**Project: Greater Karachi Bulk Water Supply Scheme, Phase-I, K-IV
Project, (260 MGD)**

**Subject: SUBMISSION OF DRAFT DESIGN REVIEW REPORT ALONG WITH
ANNEXURES BY M/S. NESPAK FOR THIRD PARTY DESIGN
REVIEW OF K-IV PROJECT.**

Hydraulic analysis & simulations

Title
Karachi WTS third party review

Figure 2.3 Discharge and pressure at the start of the rising main for PS-1.

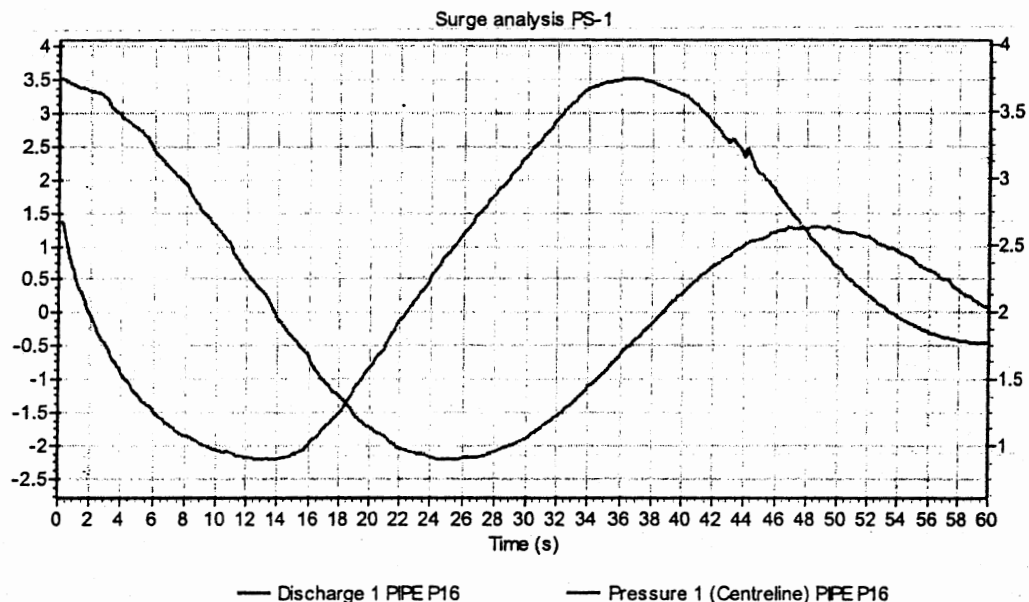
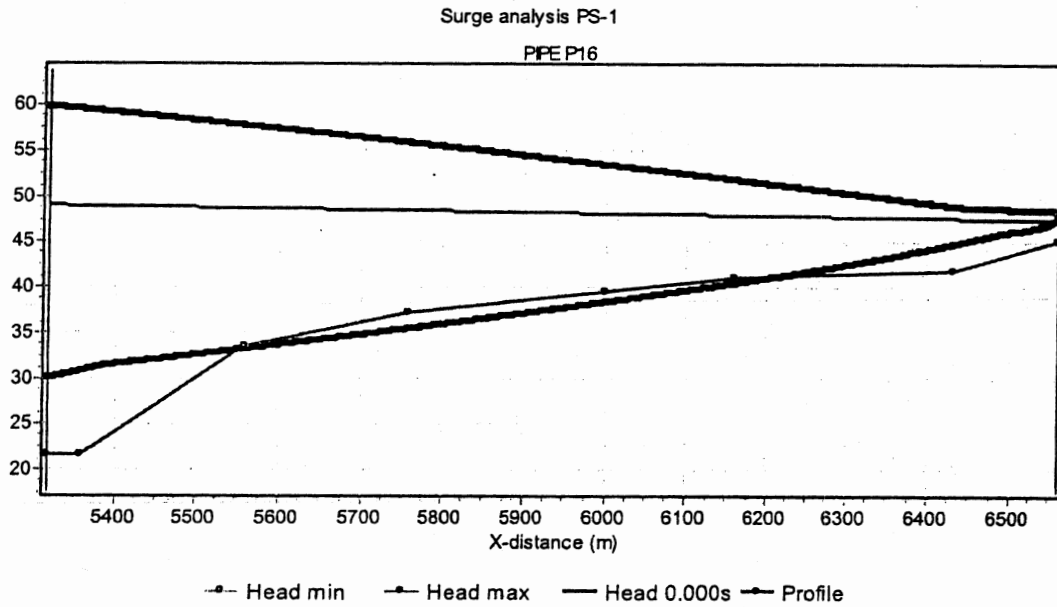
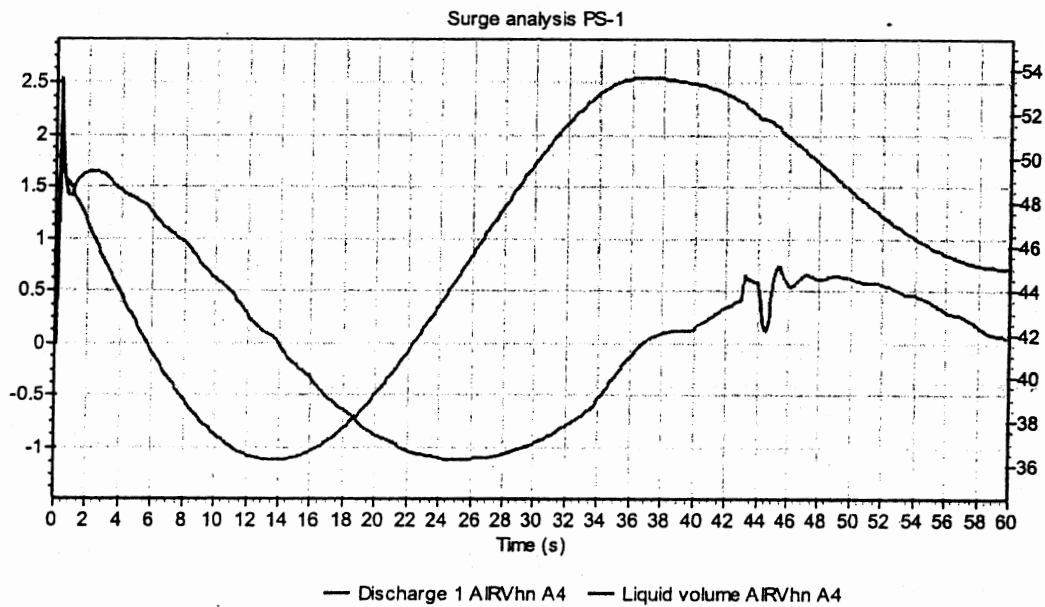
After the pumps trip, a negative pressure surge propagates from the pumps into the rising main and pneumatic vessels. The pneumatic vessels react to this by discharging into the manifold, which causes the check valves to close. When the check valves are closed, the discharge from the pneumatic vessels propagates into the rising main, preventing negative pressures. When the pressure surge reaches the forebay it is reflected and travels back to the pneumatic vessels. The water level in the pneumatic vessels decreases due to the discharge into the rising mains, causing the pressure in the pneumatic vessel to decrease. The low pressure in the pneumatic vessels causes the liquid column in the rising main to decelerate and reverse flow direction. The reverse flow causes the water level in the pneumatic vessels to rise (refilling), increasing the pressure. When the pressure reaches the set point of the pressure relief valve, it briefly opens and discharges into the pump sump. The pressures in the rising main and pump manifold remain well within acceptable limits.

From the simulation results discussed in the previous chapter, it is concluded that the surge protection as specified in the pumping station design report suffices to protect the pumping stations and rising mains during a full pump trip.

However, the design allows for optimization of the surge protection because the current surge protection equipment (pneumatic vessels and pressure relief valves) are larger than what is necessary.

Figure 2.6 Discharge and pressure at the start of the rising main for PS-2.

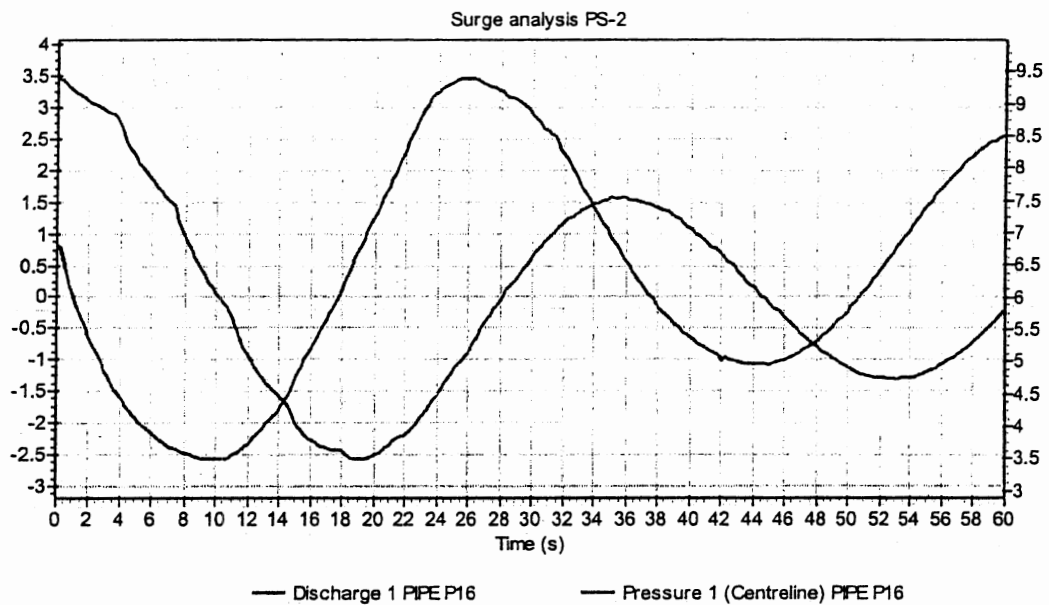
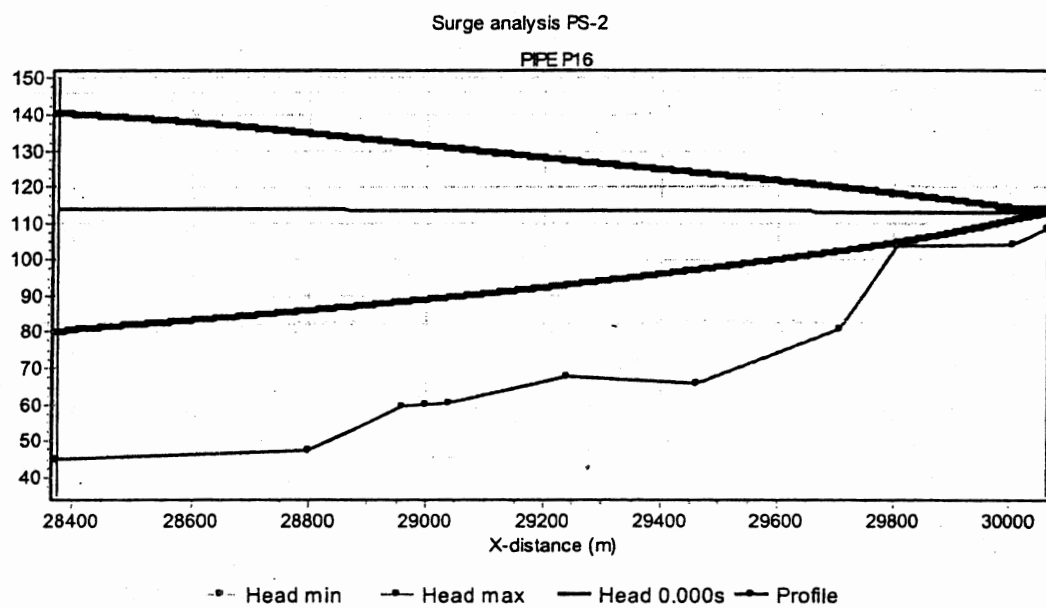
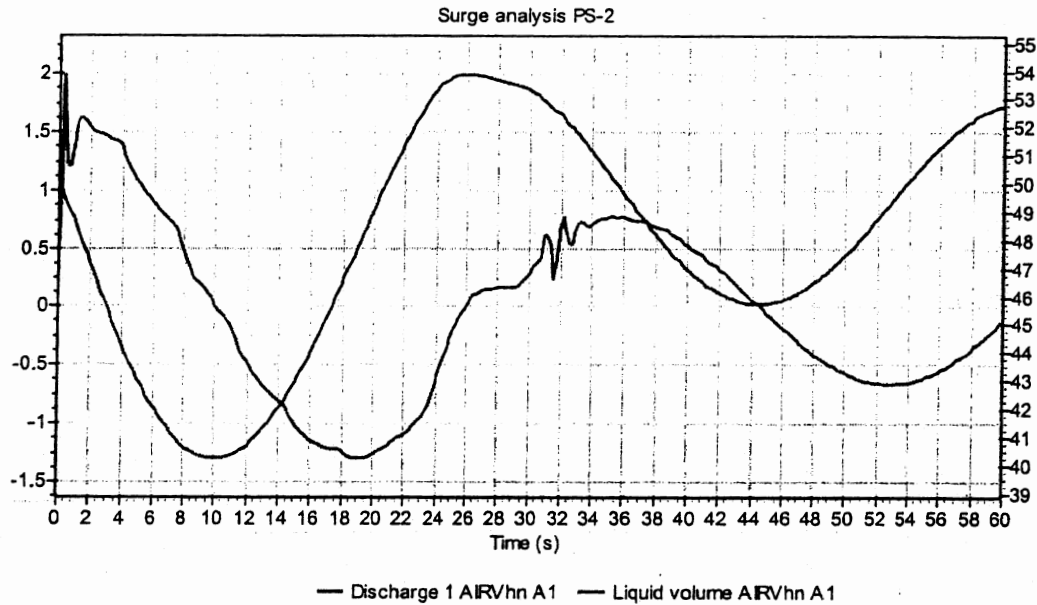
The Hydraulic behavior of the pumping stations is identical due to the similarities in their layout and design, therefore, only the behavior of PS-1 is discussed in detail. The figures for the surge analysis of PS-1 and Rising main 1 are shown in Figure 2.3 through Figure 2.5. The results for PS-2 and rising main 2 are shown in Figure 2.6 through Figure 2.8.

Figure 3.1 Head envelope of Canal Reach 2 and siphons for a discharge of 260 MGD ($13.4 \text{ m}^3/\text{s}$)

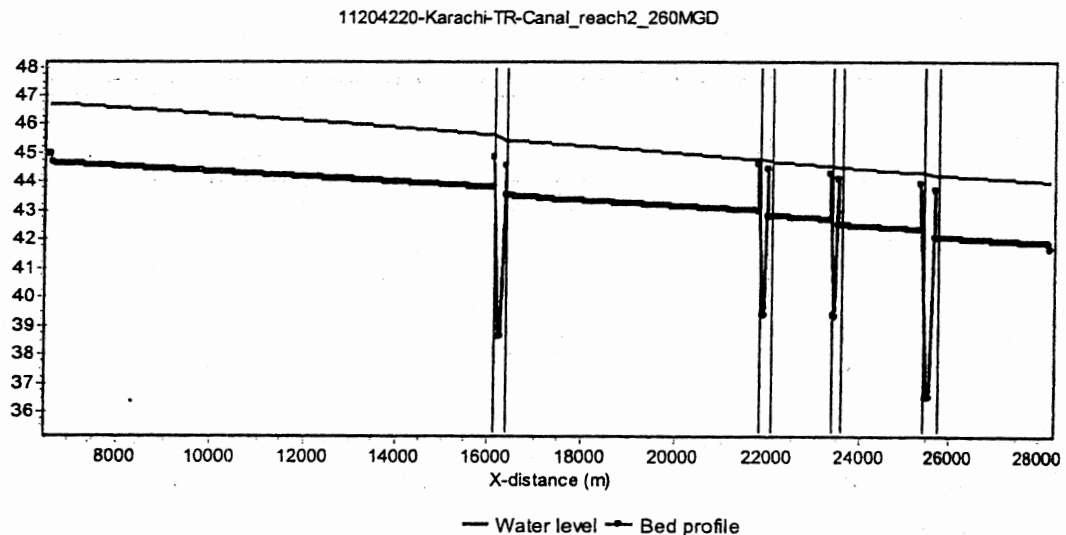
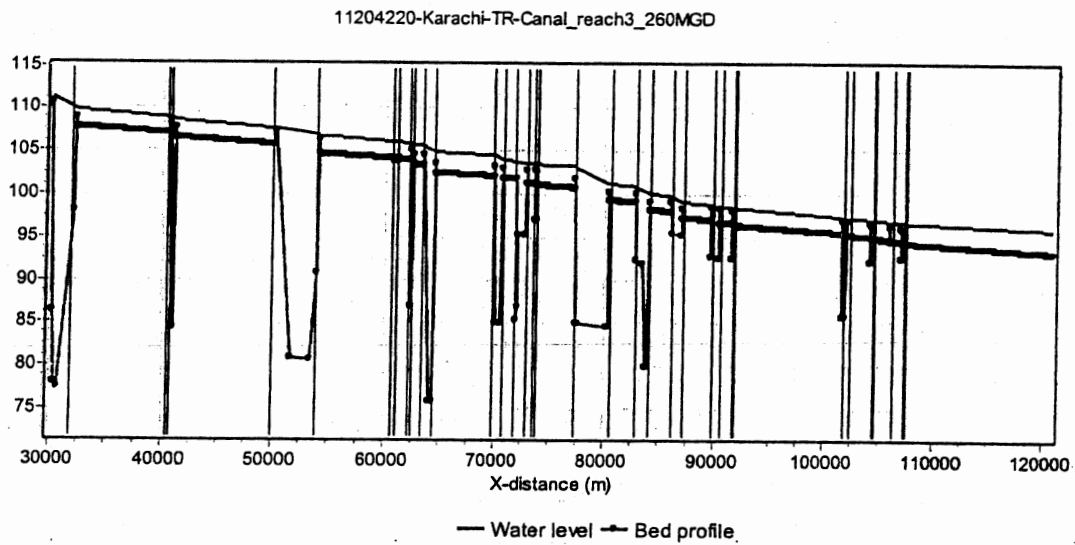
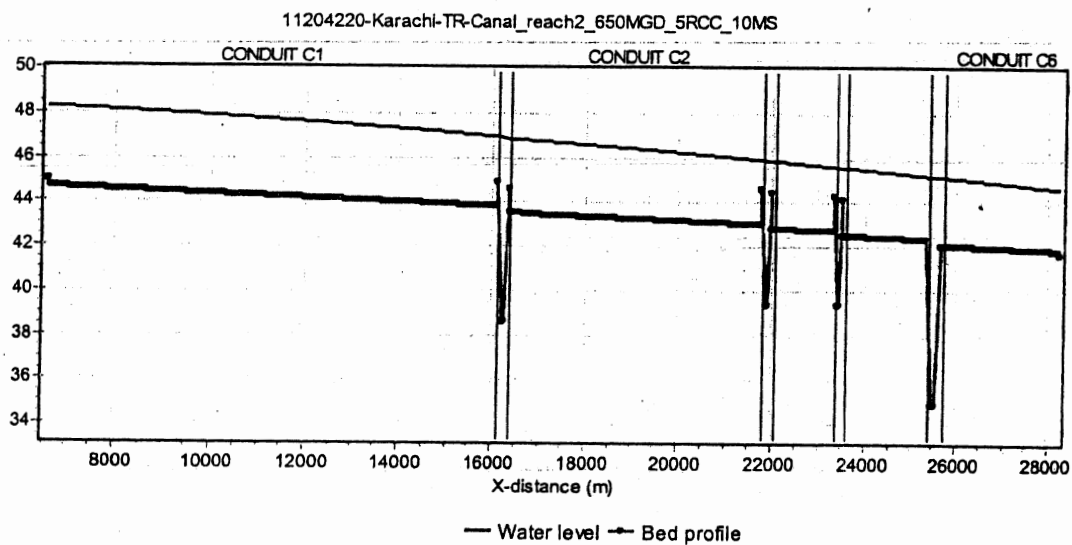
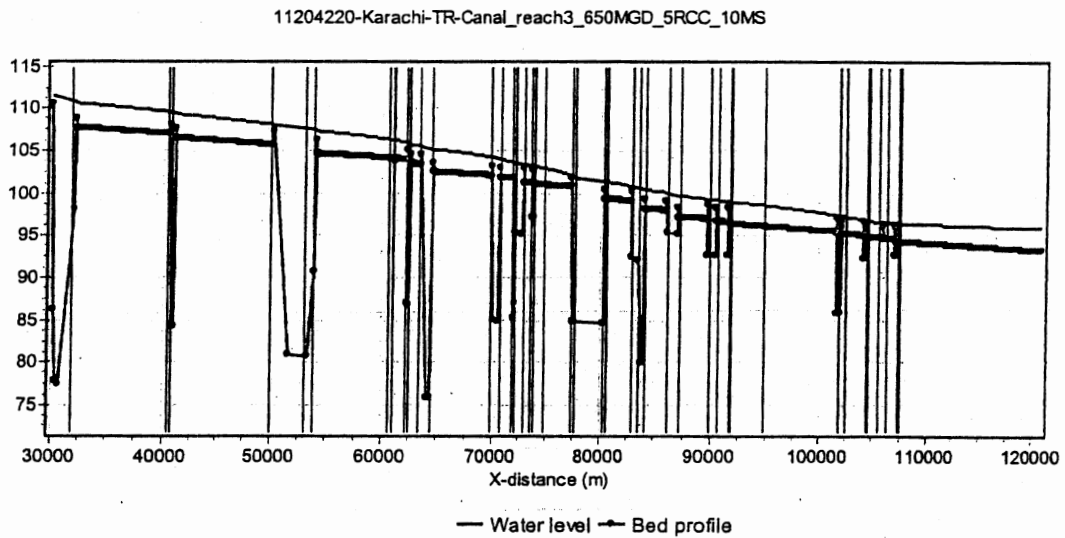
The results from these simulations have been used to verify and confirm the hydraulic calculations performed by NESPAK. There are small differences in the calculation results from Deltares and NESPAK. These differences have been analysed and discussed with NESPAK engineers and our mutual conclusion is that these differences are negligible and are caused by the differences in the numerical modelling methods that were used.

The conclusion is that the design flow rate of 260 MGD and 650 MGD can be transported by the canals and siphons. The water levels in the canal are within acceptable limits.
